AGENDA
CITY OF CEDAR FALLS, IOWA
STANDING COMMITTEE MEETING
MONDAY, FEBRUARY 05, 2024
5:15 PM AT CITY HALL, 220 CLAY STREET

EXECUTIVE SUMMERY

Hearst 2.0 Master Plan Presentation

NEW RECITAL ARCHITECTURE - VIEW TO SEERLEY BLVD.

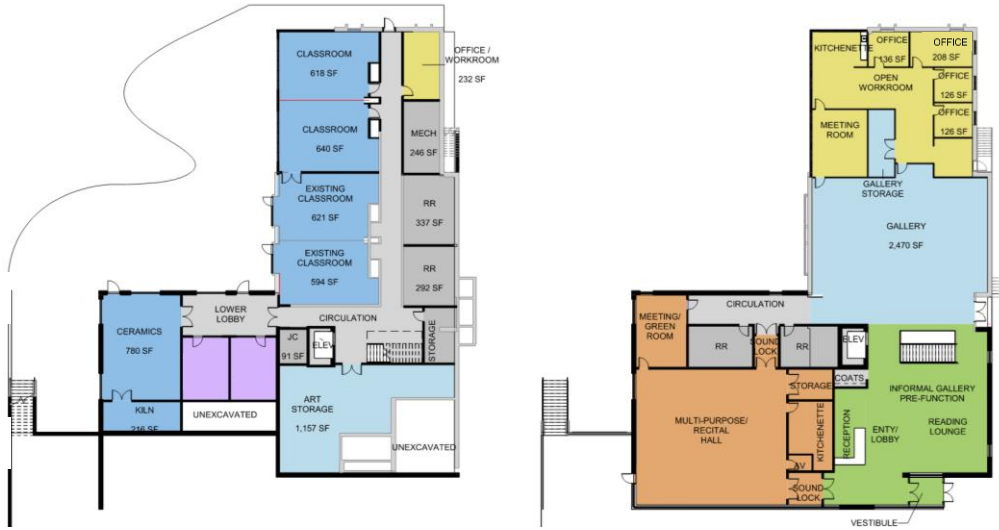
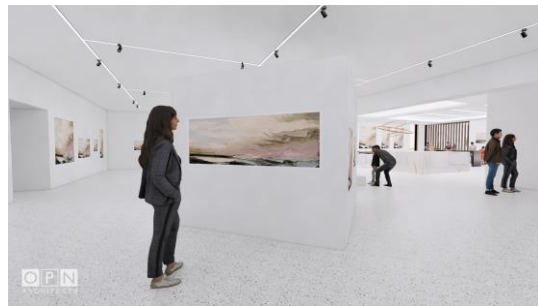
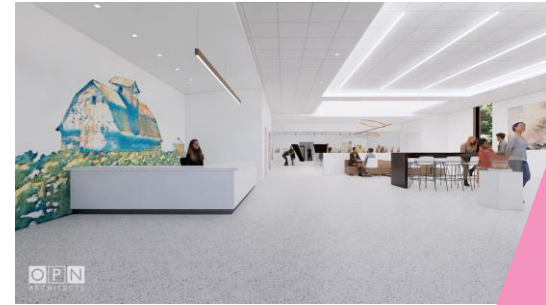
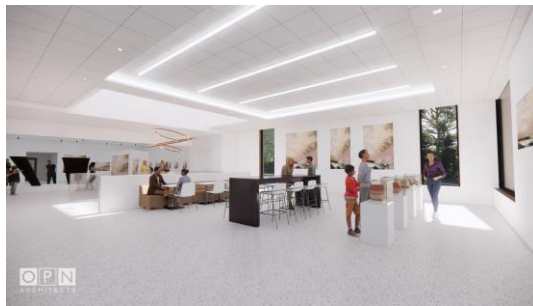
- This is the most efficient use of circulation of all the concepts
- Does have 4 classrooms and larger ceramics area with separate kiln room.

- Same comment on ed storage, and same suggestion.
- Gallery storage on upper floor would benefit from having New Recital Architecture - View to Back Patio concept's workspace area instead.
- We need a secure closure for the main gallery from lobby
- Patio is too large for this site

The "NEW RECITAL ARCHITECTURE - VIEW TO SEERLEY BLVD" served as the foundation for the preferred concept. The revisions were made to address concerns identified during the prior review process. An interior design study was initiated to explore the potential configurations and aesthetics of the interior spaces.
